Re: KIA Comments on 2019 Annual Geotechnical Inspection Report for the Tailings Impoundment Area Hope Bay Project, Nunavut

Reproduction of TMAC Responses to KIA-NIRB-37 through KIA NIRB-42 (TMAC, submitted September 4, 2020)

Figure 4: Pad-T As-Built Waste Rock Pile

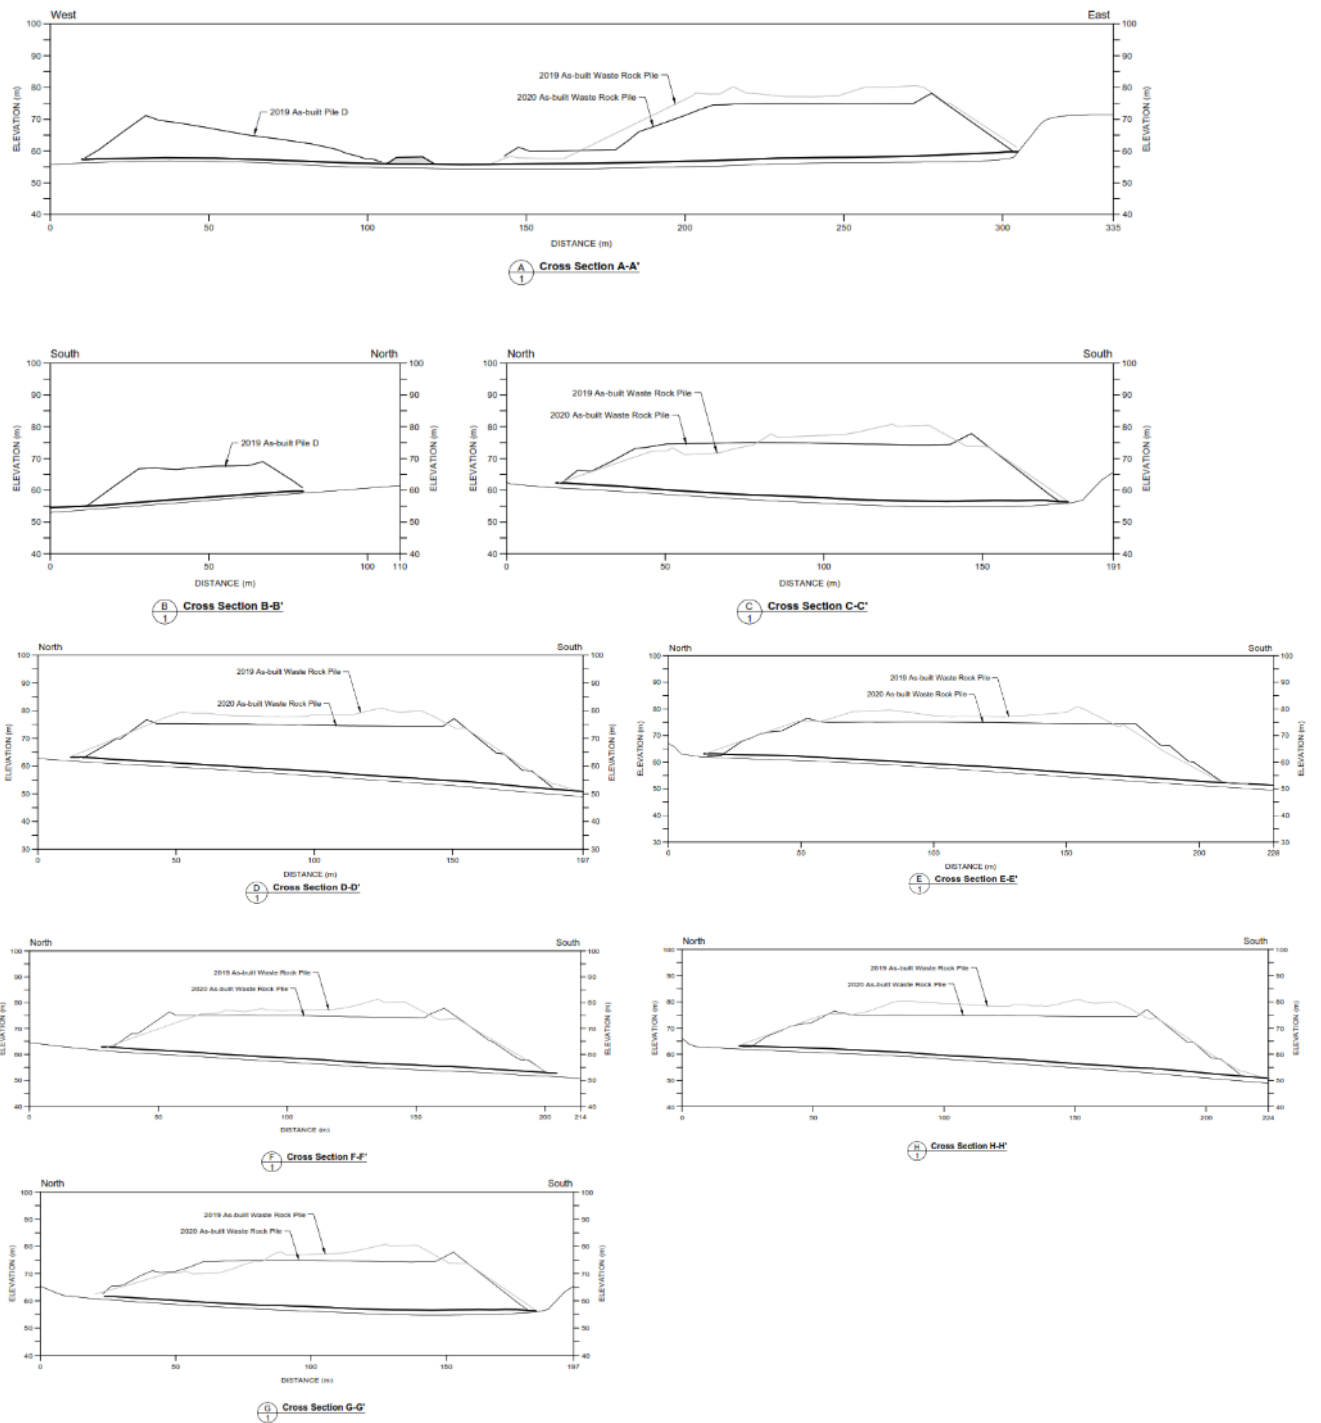
Based on SRK's inspection of the waste rock pile on Pad T, the pile was noted to be both over-steepened and to exceed its maximum design height. TMAC's response was that the waste rock pile has been re-worked to reduce the height and slope angles and will continue to work with SRK to achieve the design parameters and safety factors. No details on the observed height or slope angles were provided.

Provide the current (regraded) geometry of the waste rock pile and if not within the design criteria, an assessment of current safety factors and a plan to comply with the design criteria.

The figures below provide the current (regraded) geometry of the waste rock pile (based on an August 2020 physical survey). As demonstrated in the figures, TMAC has conducted re-sloping of the waste rock pile since SRK's observations were noted in 2019. Checks completed have confirmed a Factor of Safety (FoS) above 1 and TMAC continues to work with SRK to ensure the long stability of the waste rock pile with a FoS in the 1.4+m range. It is noted, for a short term safety measure additional catch / safety berms have been placed around the area (upstream of the portal face) where risks from rolling rocks or shallow slope sloughing exist.
